MINUTES OF THE
FAIRFIELD BOARD OF ZONING APPEALS

June 5, 2013

RE: Screening Elements - Rolling Hills Baptist Expansion

Attachment

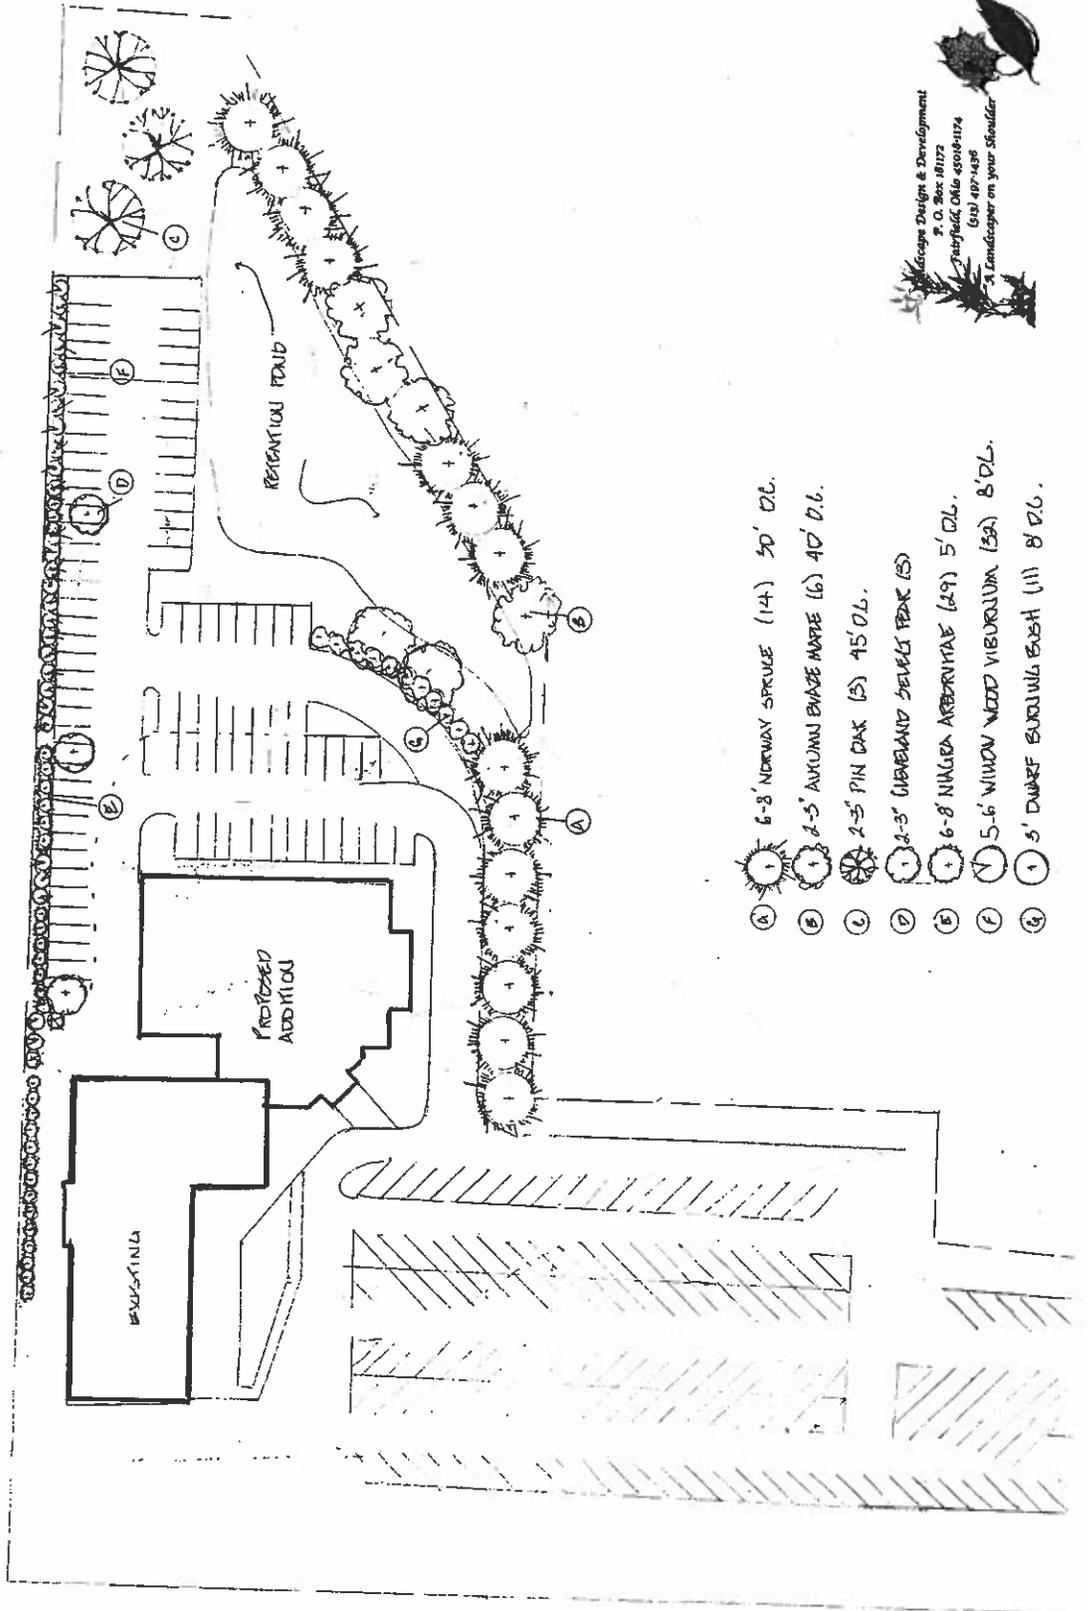
1. The Norway Spruce trees on the south property line near the drive should be staggered about 2-3 feet and two additional Spruce trees should be added reducing the spacing which is currently 30' O.C. The trees should be moved as close to the property line as possible so as to give them the best ability to mature given the driveway that is proposed adjacent to them.

2. The Norway Spruce and Autumn Blaze Maple screening the retention basin again should be staggered 2-3'. There is some question that the deciduous Maples may not provide the 60% opacity so it is being recommended that the Burning Bush row currently planned for the area west of the basin be augmented by extending the row north to the edge of the future parking. Approximately 10-11 additional bushes should accomplish this.

3. The trees and bushes need to be maintained with appropriate watering/fertilizer etc. especially after planting for them to remain healthy and produce the desired screening effect.
